SERVICE BULLETIN

Classification: BT21-023	Reference: NTB21-116	Date: December 13, 2021
-----------------------------	-------------------------	----------------------------

PASSENGER FRONT DOOR GLASS SQUEAKS WHEN GOING UP AND DOWN

APPLIED VEHICLES: 2021 Rogue (T33)
APPLIED VIN AND DATE: VINs starting with **5N1** and built before September 15, 2021

Figure 1

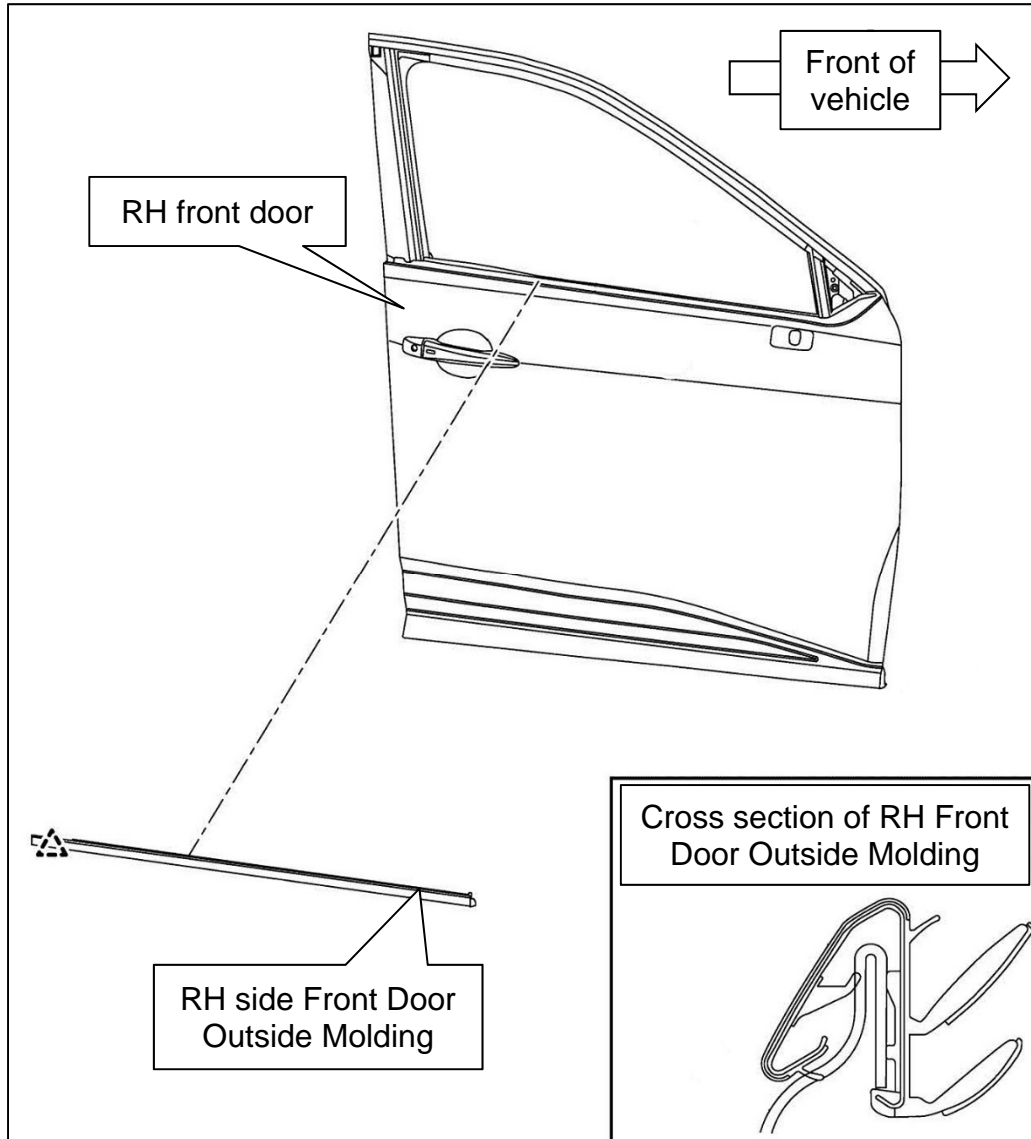
1. Replace the RH side Front Door Outside Molding.
 - Refer to the ESM: **BODY EXTERIOR, DOORS, ROOF & VEHICLE SECURITY > EXTERIOR > REMOVAL AND INSTALLATION > DOOR OUTSIDE MOLDING**

2. Clean the RH side front door glass.
3. Confirm that the noise is no longer present.
